MEETING SUMMARY

Throat Area/ Charles River Working Group, Allston Multimodal Project
July 30, 2024

Subject: New Option 5 Design Concept: Throat/River Edge, I-90 AMP

**New Conceptual Design:
Option 5: Retained Fill/
Sloped River Edge**

**New Conceptual Design:
Option 5: Retained Fill/
Sloped River Edge**

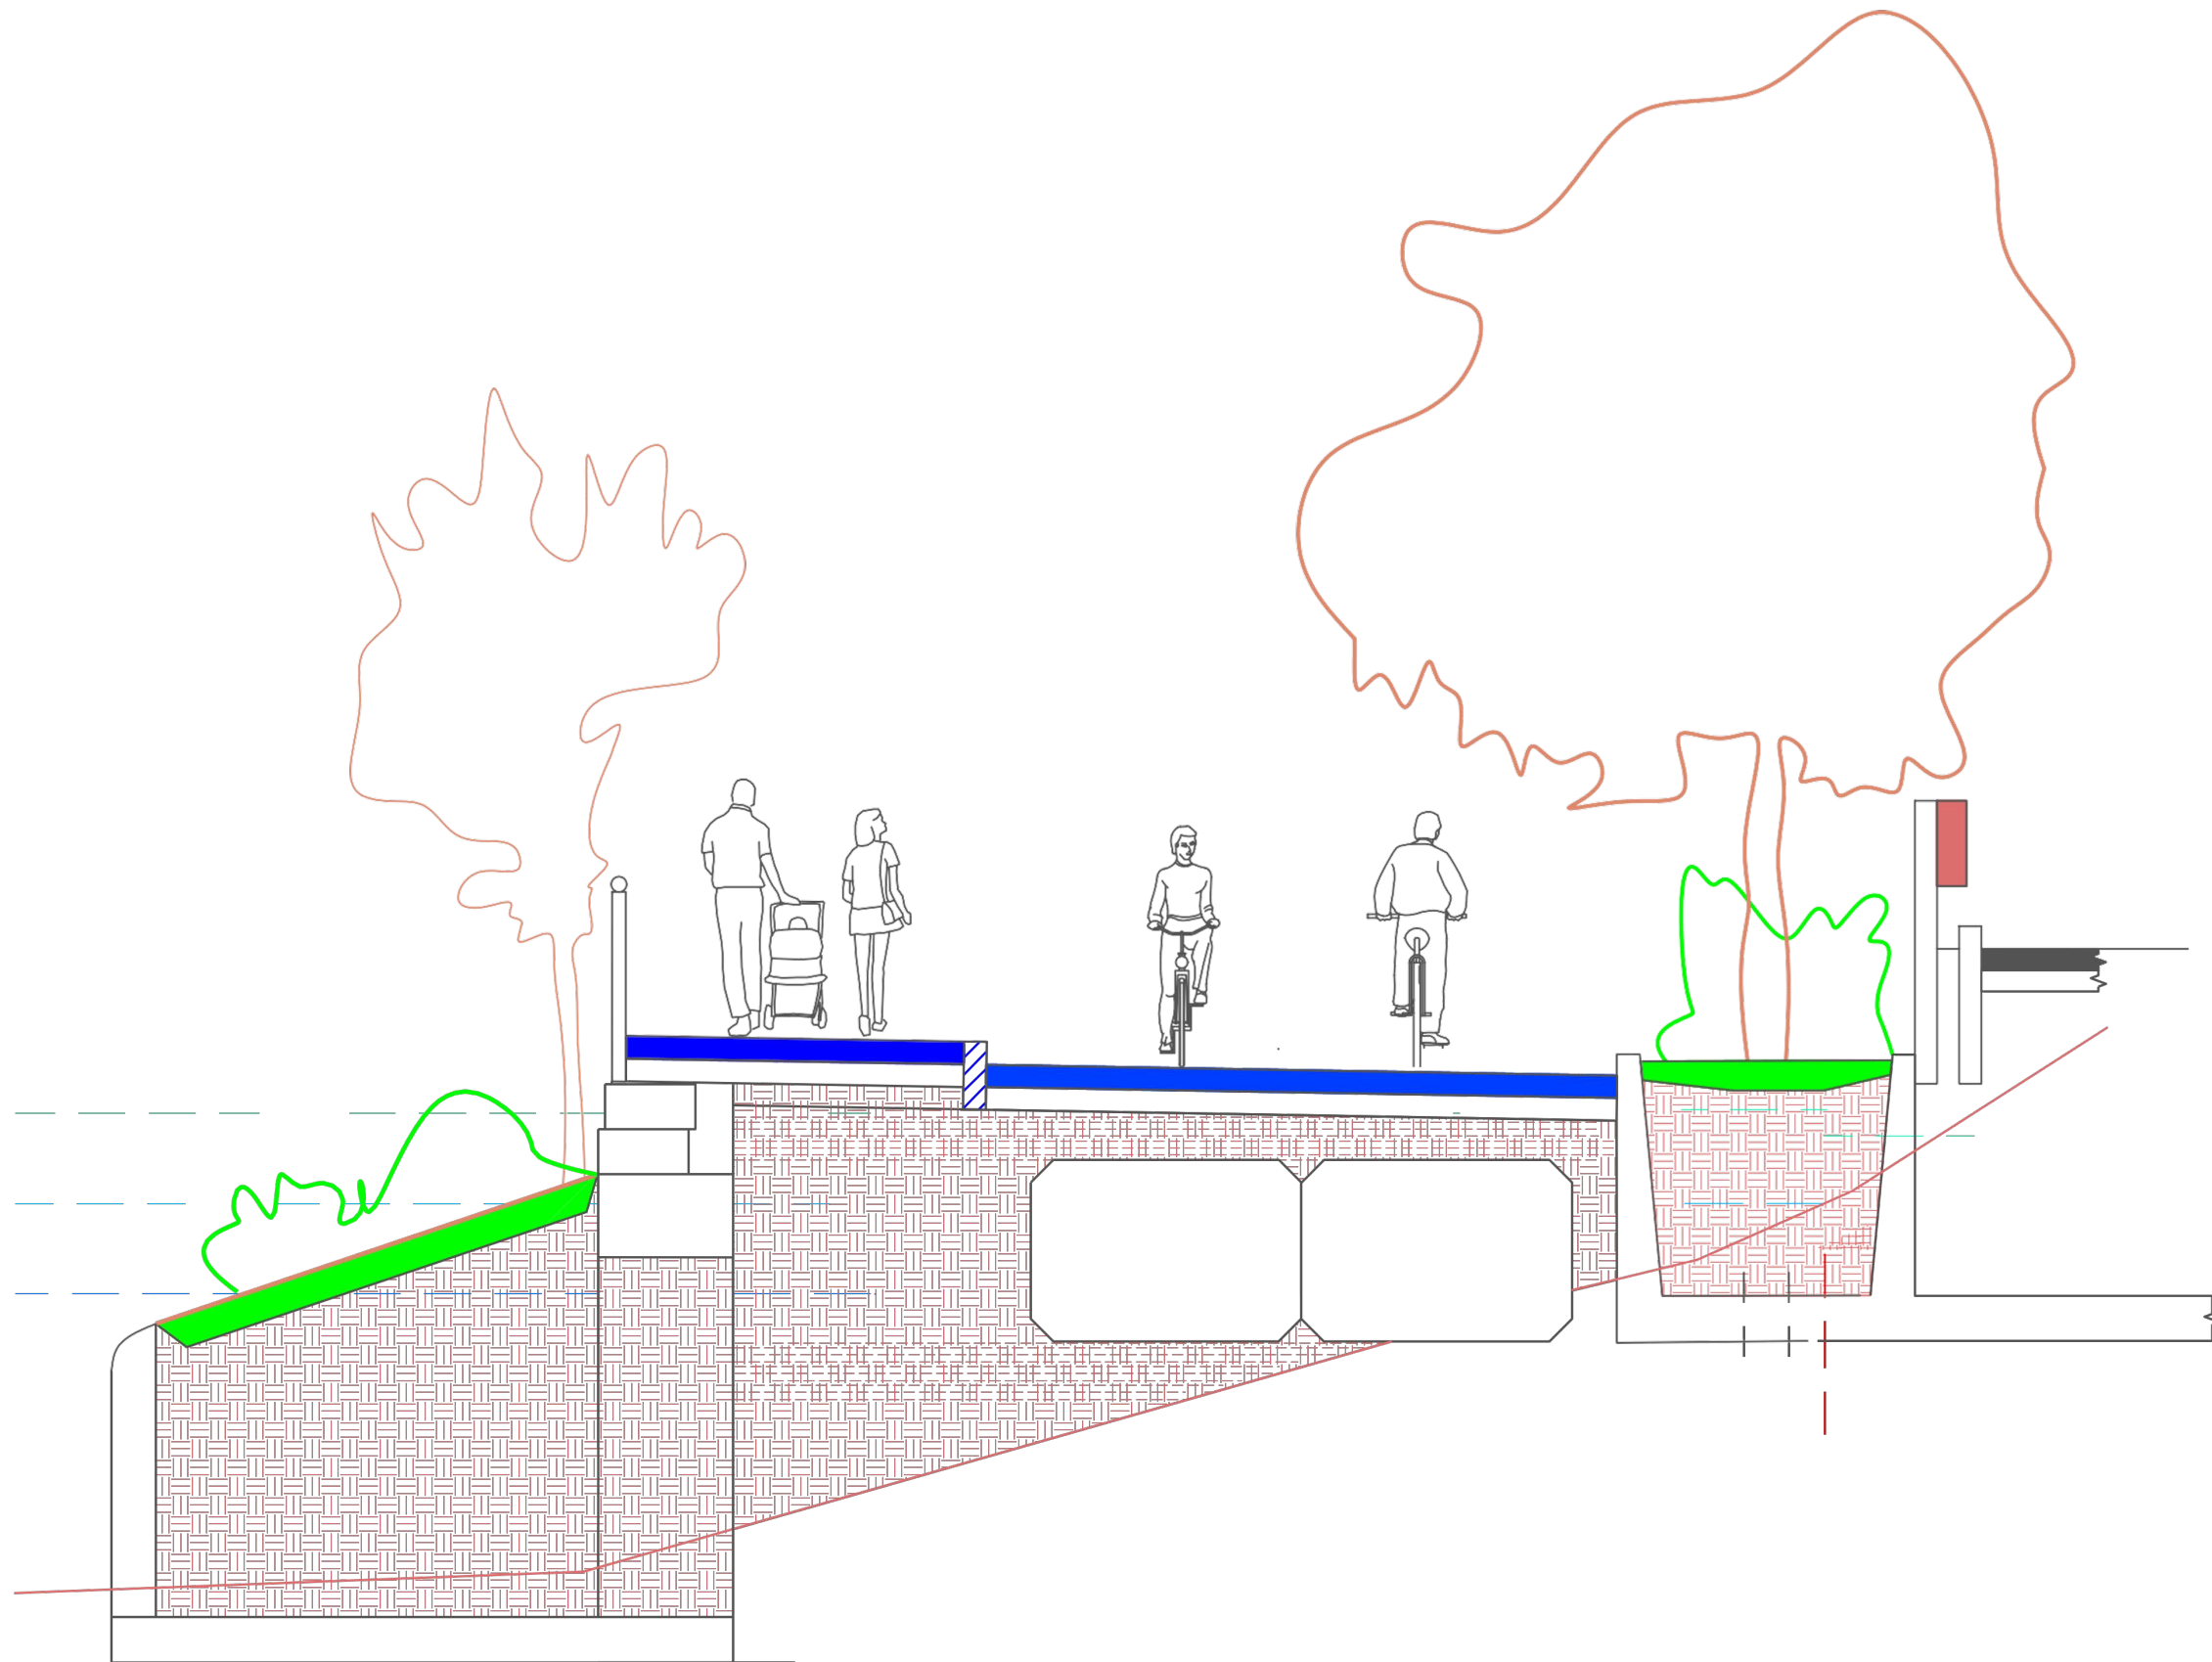
1. To provide the additional width of 2' needed to accommodate this Throat/River Edge design concept, SFR lanes shall be reduced from 10'-6" to 10'-0" (see DCR Historic Parkway Preservation Treatment Guidelines dated 2007).
2. Excerpt, MassDOT Separated Bike Lane Planning & Design Guide (2015), Section 3.3.2, Exhibit 3I: Bike Lane Widths for Two-way Operation, pp. 31.:

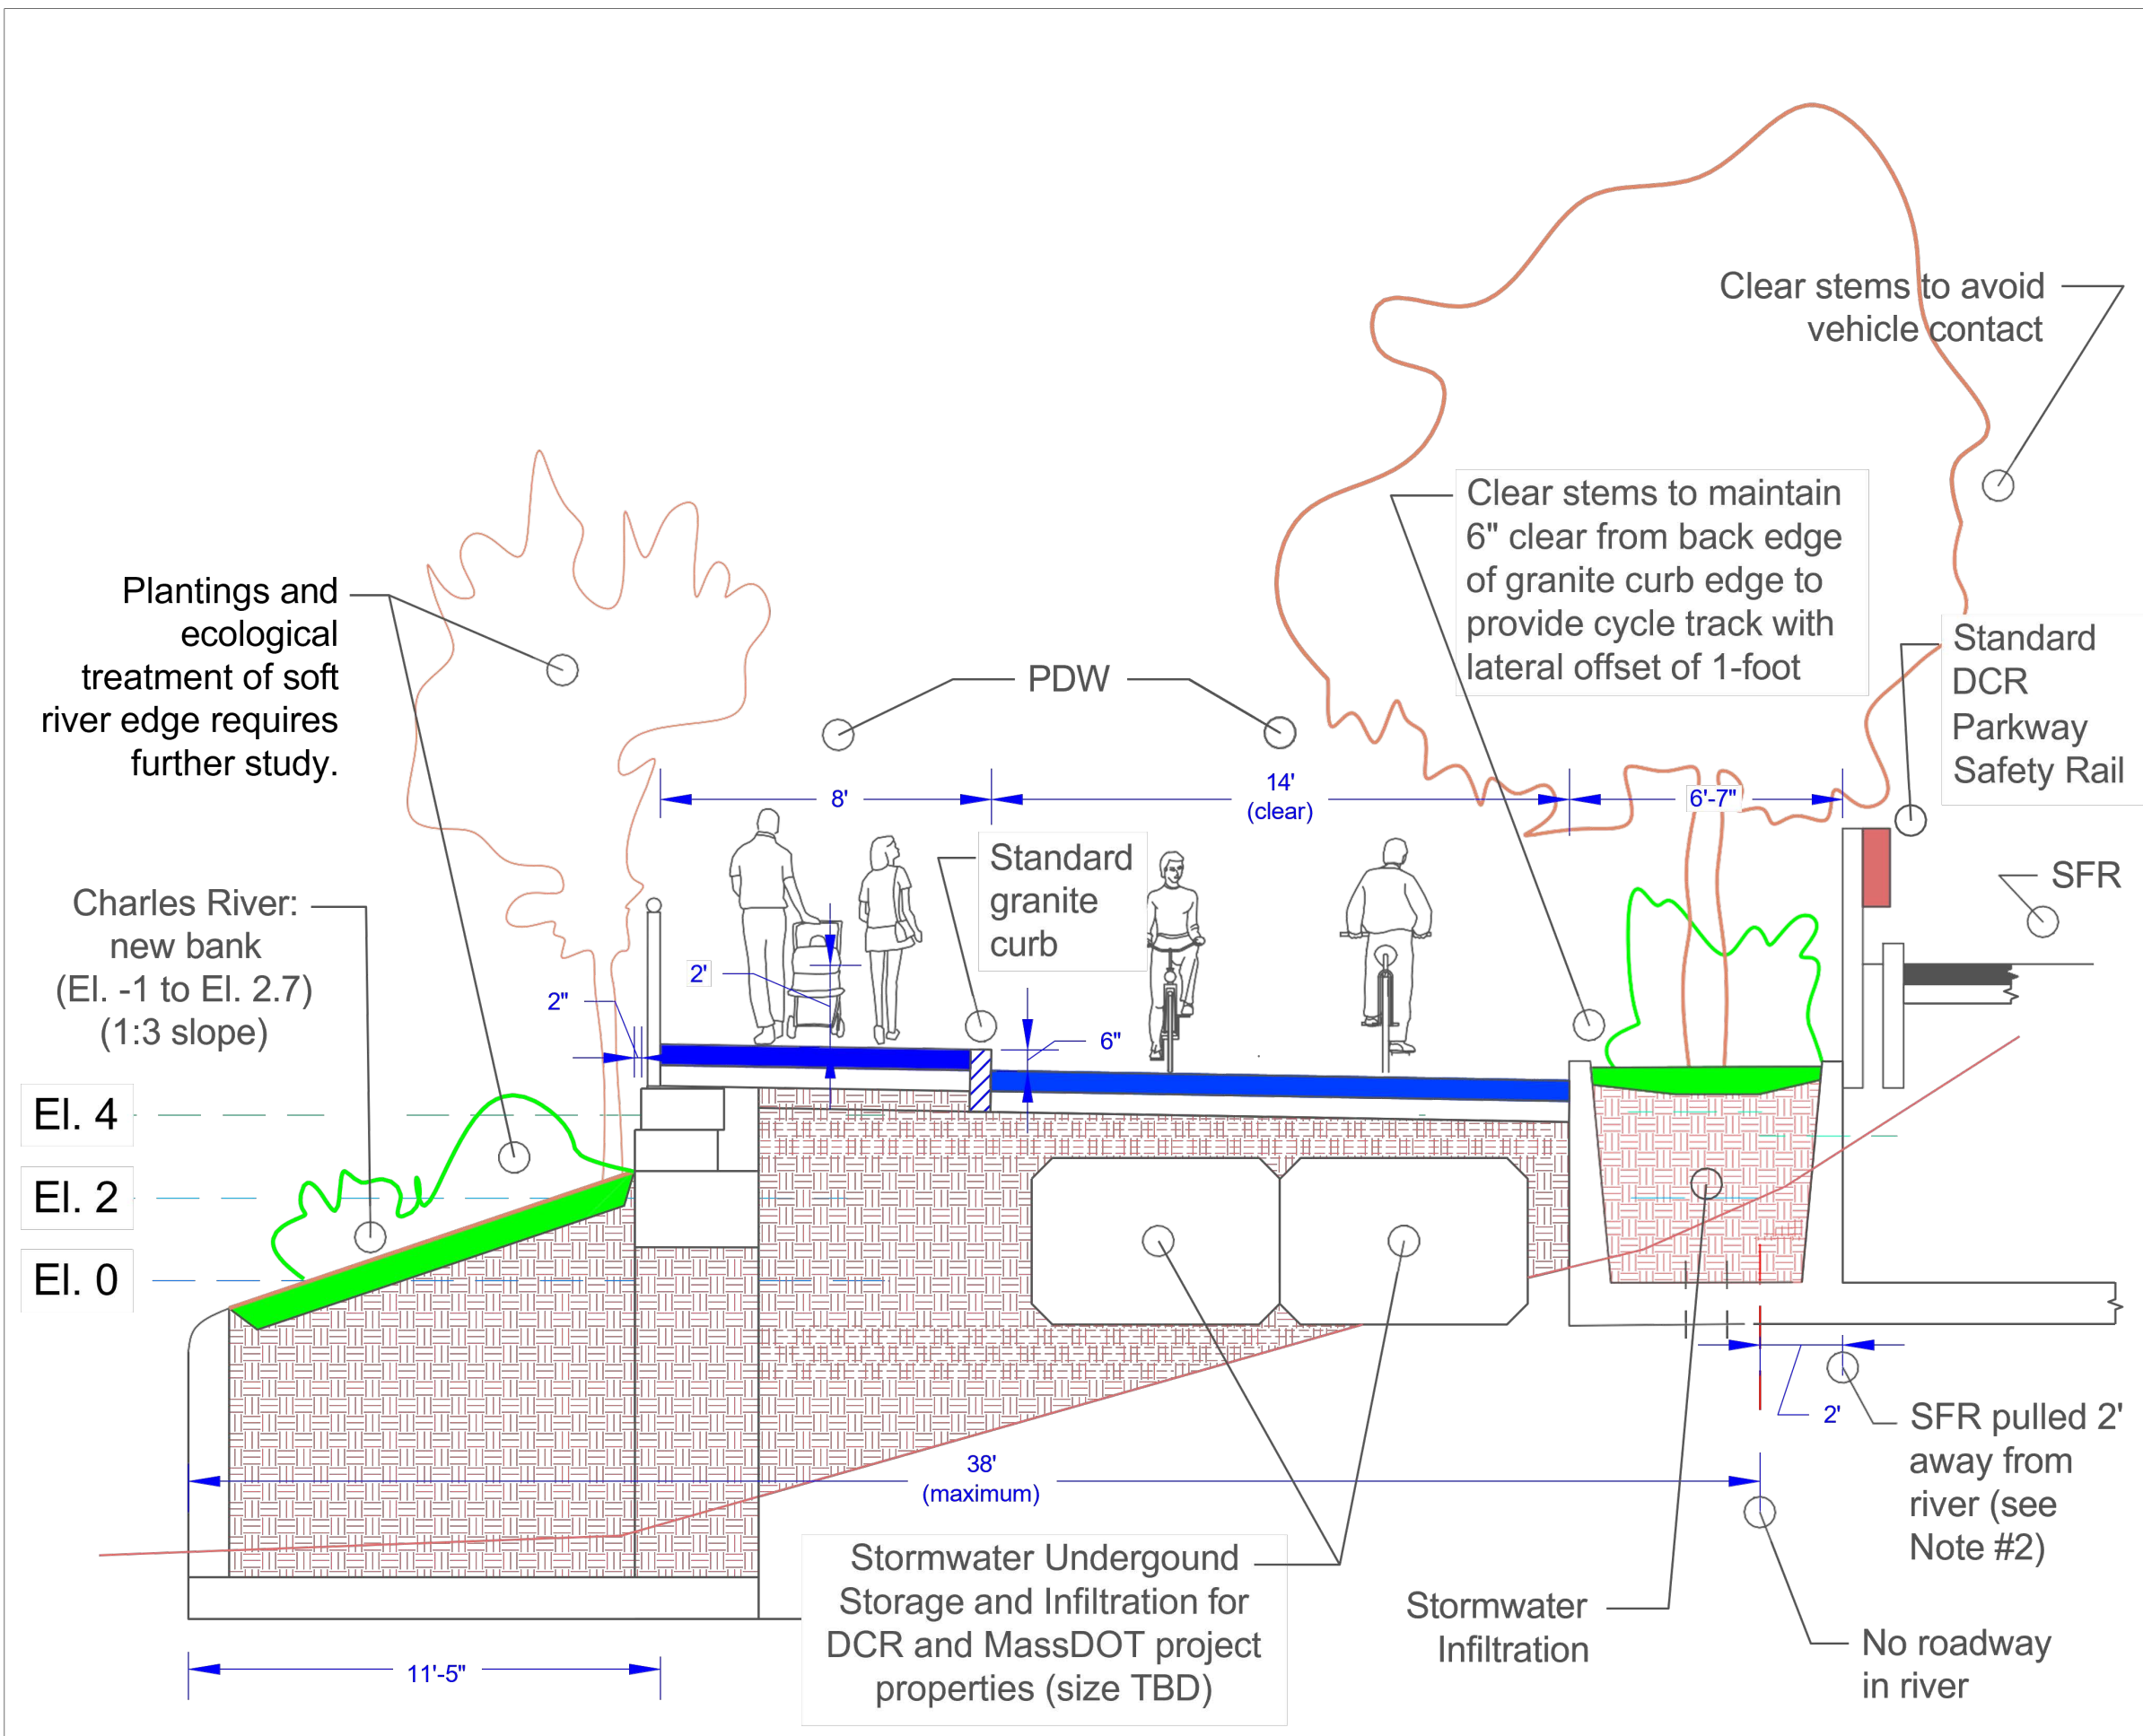
The Option 5 cross-section is 38-feet (maximum) in width at the narrowest part of the Throat, and thus satisfies MassDOT's objective to limit river fill to less than one-acre in accord with New England District of the U.S. Army Corps of Engineers (USACE) General Permit regulations.

Working from the new river edge in, Option 5 contains a sloped natural river edge similar to what MassDOT showed the Working Group on Tuesday, except our edge runs between El. -1 and El. 2.5 (NAVD88 datum) which then transitions to a very short (about 2-foot) stepped granite block wall. We believe starting the new edge below El. 0 is extremely important both to minimize wave reflection and to allow river users needing to gain rapid and safe egress out of the water be able to do so. The plans note that locked gates or other means to provide for DCR maintenance require further study. We are confident that matter can be resolved.

With respect to pedestrian and bicycle accommodations, a single, shared multi-use pathway is not acceptable here. For that reason, we strongly recommend the separated pedestrian and bicycle paths depicted in Option 5. The pedestrian path is 8-feet wide, and grade separated from the cycle-track by a standard granite curb. The two-way cycle track is 14-feet wide in accordance with MassDOT design standards and in full support of city/state climate change and public health objectives.

Option 5 includes a landscape buffer between the new river park spaces and Soldiers Field Road (SFR) in the Throat. This important planting area is about 6.5-feet wide—more than sufficient to grow large shade trees. We are confident that the SFR and park space interface can be designed to minimize if not preclude any possible infrastructure damage from tree growth. To provide for the various widths as shown in Option 5, the plan calls for reducing the width of the lanes on SFR from 10.5-feet to 10.0-feet, in accordance with DCR Parkway Design Guidelines. Finally, Option 5 improves upon the At-Grade Option goal of having no roadway in the river by moving SFR two-feet further away from it.

1. Base taken from MassDOT Slide Deck Option 1 as presented to Task Force on June 10, 2024
2. Cross-Section looking eastward towards downtown Boston.
3. See Sheet #2 for dimensions and additional notes.
4. Buffer trees between SFR and PDW shall be 5" caliper (min.) to maximize shade.
5. Pedestrian railing to have locked gates and/or other means of egress as needed for maintenance of river edge in Throat. Requires further study.
6. Barrier height between SFR and I-90 shall be raised to reduce highway noise impacts on Paul Dudley White pathways and river edge.
